Access Compliance Report

Public Rights-of-Way

Intersection ID: 5386	Main Street: THOMPSON_RD	Cross Street: FIFENDRUM_LN	Location: NE
ADA ID: 5510C7AE2181	Ramp Type: PerpDiag	Initial Pass/Fail: Fail	Overall Compliance: No
Severity Score: 36.25			
Codes/Mitigation Info/Possible Solution		Field Measurements/Component Compliance

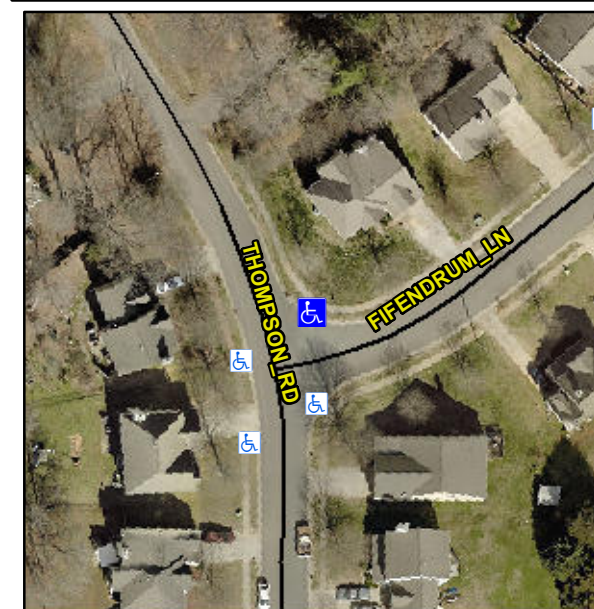
Not Found, R304.5.1, R304.5.3

Compliance	Description	Data	Compliance	Description	Data
N/A	Ramp Length (in)	80.0	Yes	Ramp Slope (%)	7.2
No	Ramp Width (in)	31.0	No	Ramp XSlope (%)	3.0
N/A	Flare Type LT	N/A	N/A	Flare Type RT	N/A
N/A	Flare Slope LT (%)	N/A	N/A	Flare Slope RT (%)	N/A
N/A	Flare Traversable LT?	N/A	N/A	Flare Traversable RT?	N/A
N/A	Landing Length (in)	N/A	N/A	DWS Provided?	N/A
N/A	Landing Width (in)	N/A	N/A	DWS Contrast?	N/A
N/A	Landing Slope (%)	N/A	N/A	DWS Length (in)	N/A
N/A	Landing X Slope (%)	N/A	N/A	DWS Full Width?	N/A
N/A	Landing Curb? (Y/N)	N/A	N/A	DWS Offset (in)	N/A
N/A	Shared Landing?	N/A			
N/A	Gutter Ponding?	N/A	N/A	Gutter Slope (%)	N/A
N/A	Gutter Lip Ht (in)	N/A	N/A	Gutter X Slope (%)	N/A
N/A	Painted X Walk1?	No	N/A	Painted X Walk2?	No
	X Walk 1 Direction	To SW		X Walk 2 Direction	To S
N/A	X Walk 1 Width (in)	N/A	N/A	X Walk 2 Width (in)	N/A
	X Walk 1 Slope (%)	3.4		X Walk 2 Slope (%)	2.5
	X Walk 1 X Slope (%)	1.5		X Walk 2 X Slope (%)	3.6

Remove & Replace Curb Ramp With Two New Directional Ramps or Equivalent.
